FROM: Carolina Power & Light Company ^o Raleigh, N. C. 27602 E. E. Utley		DATE OF DOC 9-19-73	DATE REC'D 9-27-73	LTR X	MEMO	RPT	OTHER
TO: Mr. Schemel		ORIG 3 signed	CC	OTHER	SENT AEC PDR _____ X SENT LOCAL PDR _____ X		
CLASS	UNCLASS XXX	PROP INFO	INPUT XXX	NO CYS REC'D 40	DOCKET NO: 50-261		
DESCRIPTION: Ltr furnishing info re Irradiation Surveillance Program & submitting revisions to the Tech Specs.....W/Attached Figure 1, Figure 3.1-1 & Figure 3.1-2.....				ENCLOSURES: Do Not Remove ACKNOWLEDGED			
PLANT NAME: H. B. Robinson Unit # 2

September 19, 1973

Serial: NG-73-410

H. B. ROBINSON UNIT NO. 2
 LICENSE DPR-23
IRRADIATION SURVEILLANCE PROGRAM

FIGURE 3.1-1

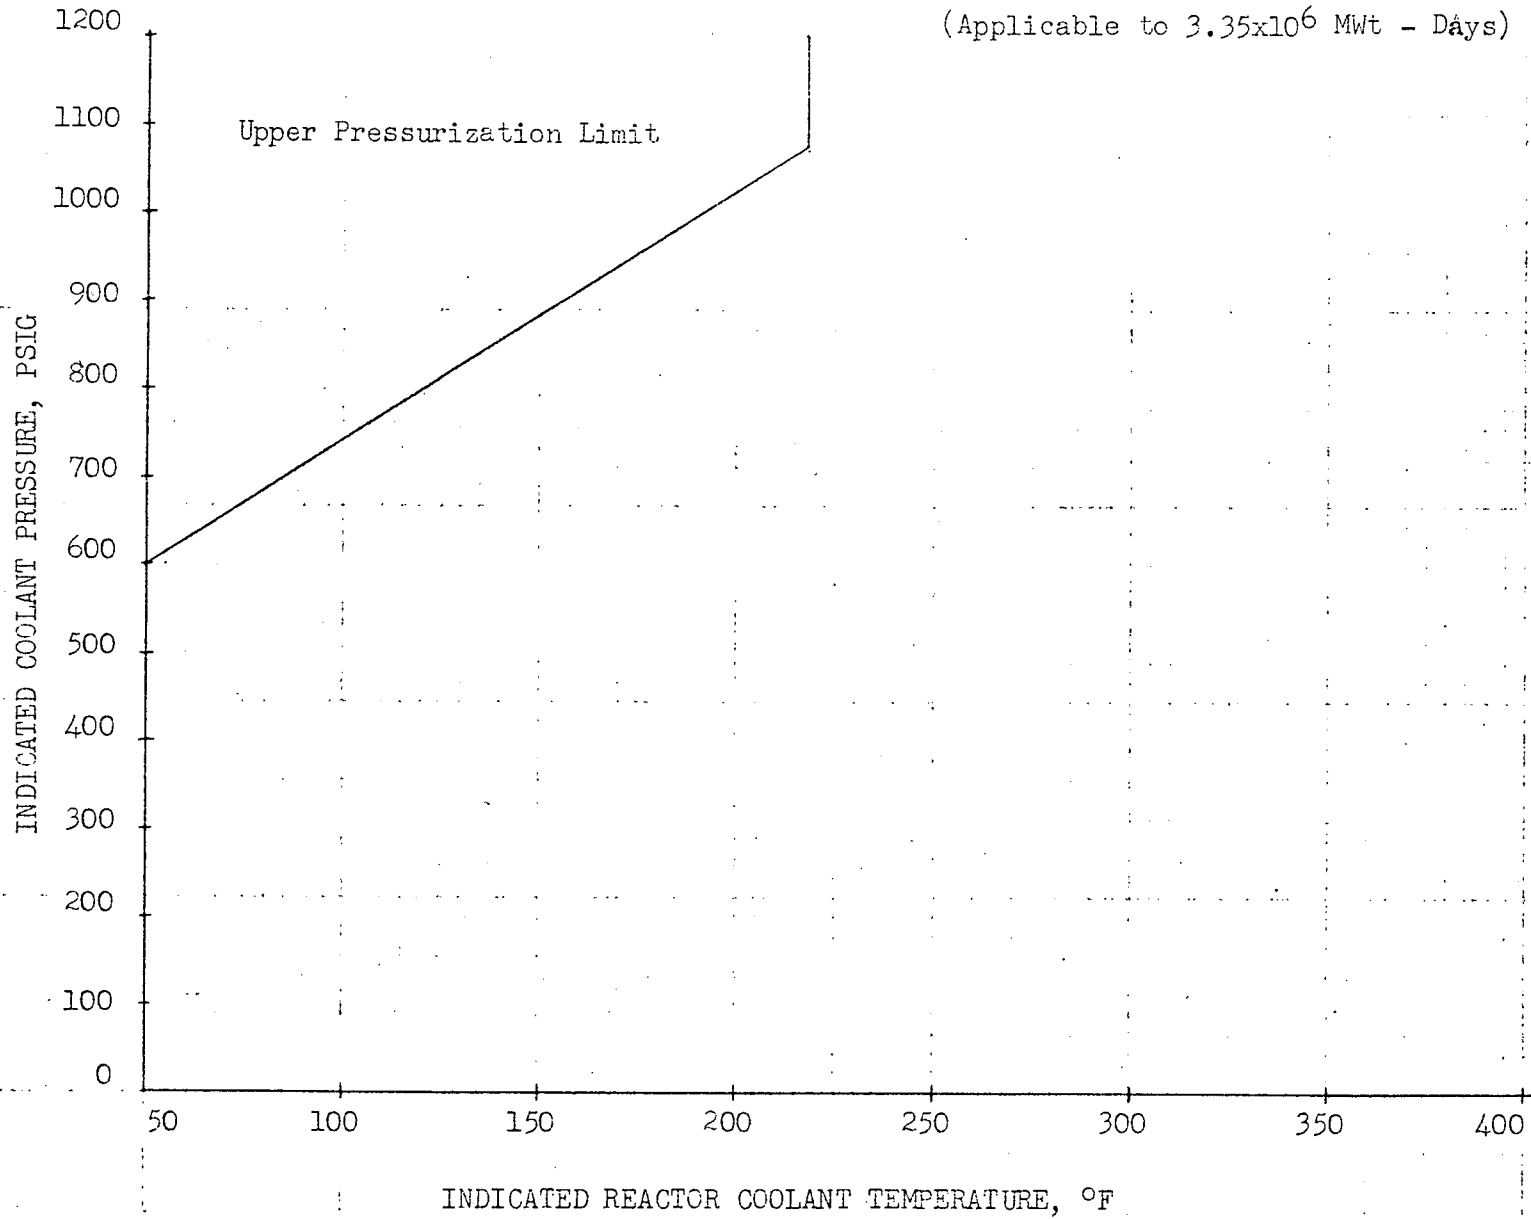
As a result of the data obtained from the capsule, various changes are required to update the plant Technical Specifications to reflect the projected neutron fluence and NDTT shift for the forthcoming surveillance interval.

The next specimen is to be removed after the fifth year of operation. This corresponds to 3.35×10^6 thermal megawatt days (≈ 1523 EFPD). The predicted neutron fast flux for this period is 4.57×10^{18} neutrons/cm² > 1 MeV. Using this value in conjunction with Figure 3.1-3 of the Technical Specifications yields an NDTT shift of 117°F. This figure is then used to arrive at a design transition temperature (DTT) to establish revised limit lines for Figures 3.1-1 and 3.1-2 of the Technical Specifications. The subject figures relate to system heatup and cooldown rates. The DTT obtained in this manner is 208°F and DTT +10°F is 218°F. The attached Figures 3.1-1 and 3.1-2 have been revised to reflect this shift. Also attached are revised pages to Section 3.1.2 of the Technical Specifications which incorporate the preceding changes.

For heatup, the thermal stress is reversed and the location of the limiting stress is a function of the heatup rate. The limit lines no longer bear the simple relationship to heatup as they do to cooldown rate. The single line shown on Figure 3.1-1 bounds all limit lines for heatup rates up to 40°F per hour for temperatures at or below 140°F, and 100°F per hour above 140°F.

(Applicable to 3.35×10^6 Mwt - Days)

FIGURE 3.1-2

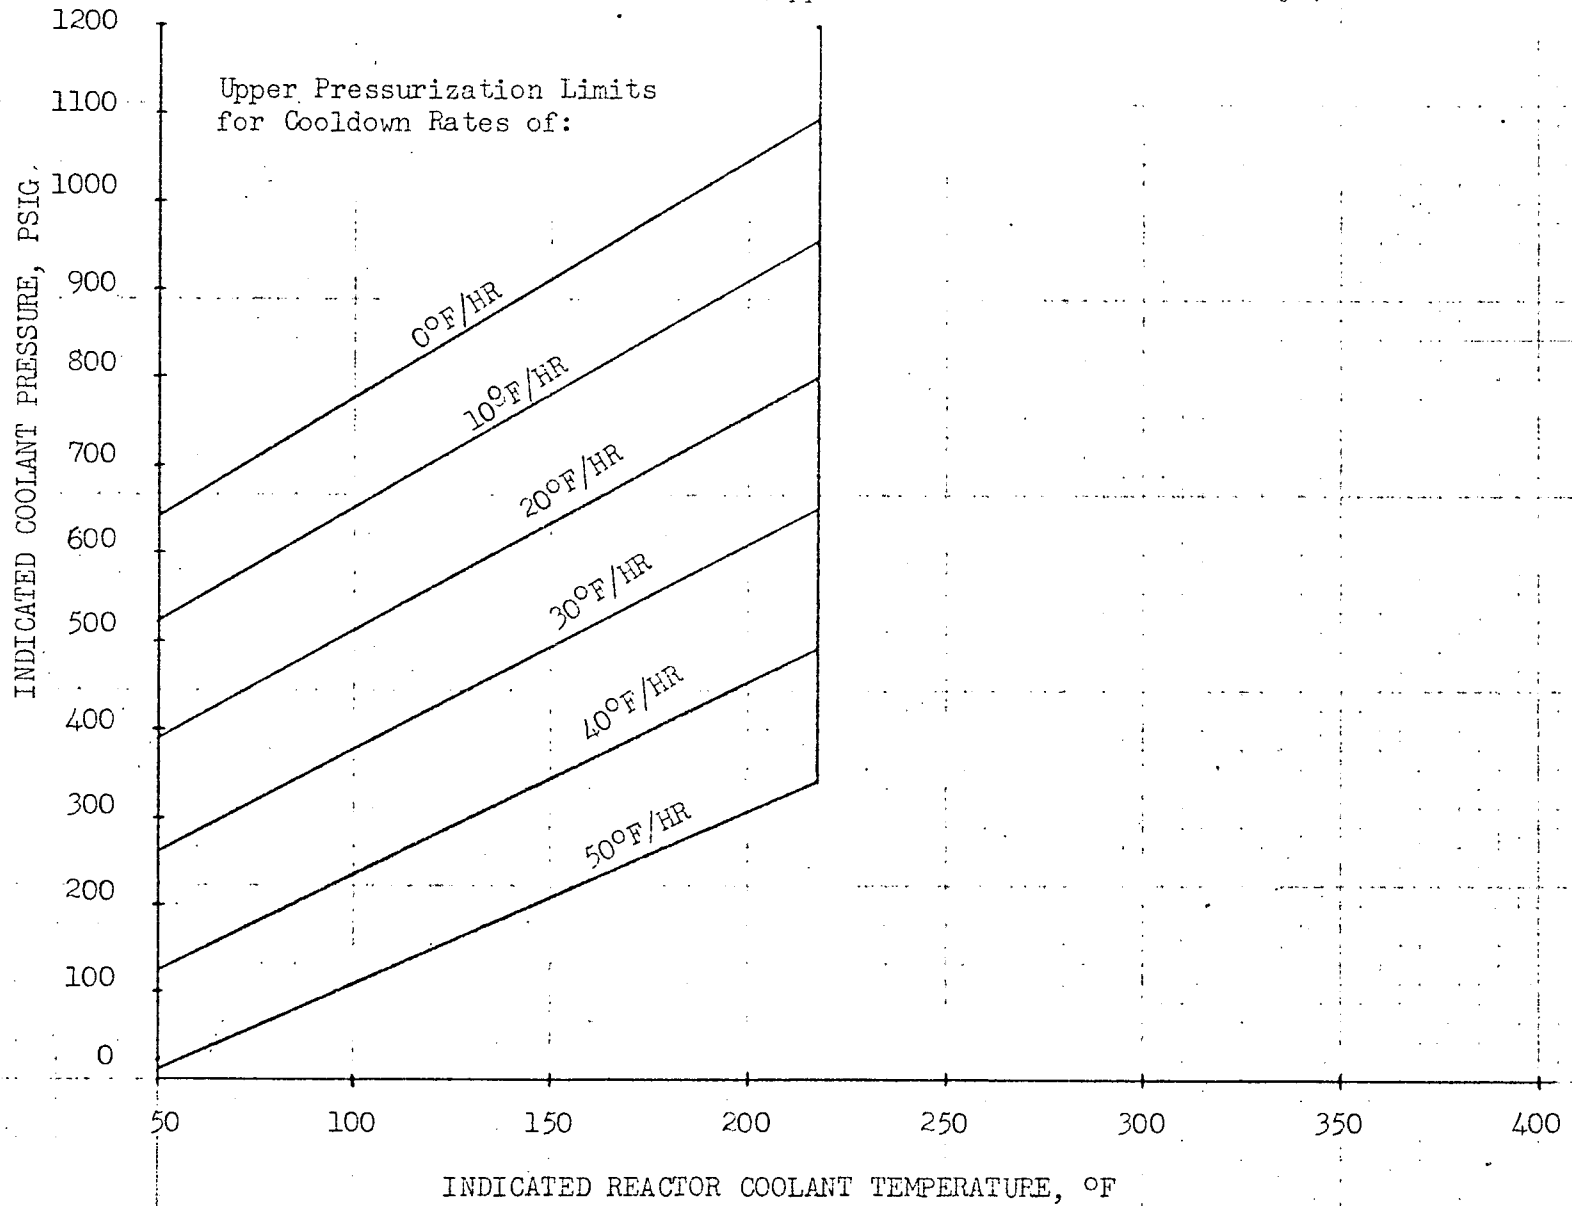
During cooldown, the thermal stress varies from tensile at the inner wall to compressive at the outer wall. The internal pressure superimposes a tensile stress on this thermal stress pattern, increasing the stress at the inside wall and relieving the stress at the outside wall. Therefore the limiting stress always appears at the inside wall, so the limit line has a direct dependence on cooldown rate. This leads to a family of curves for cooldown, as shown on Figure 3.1-2.

(Applicable to 3.35×10^6 Mwt - Days)
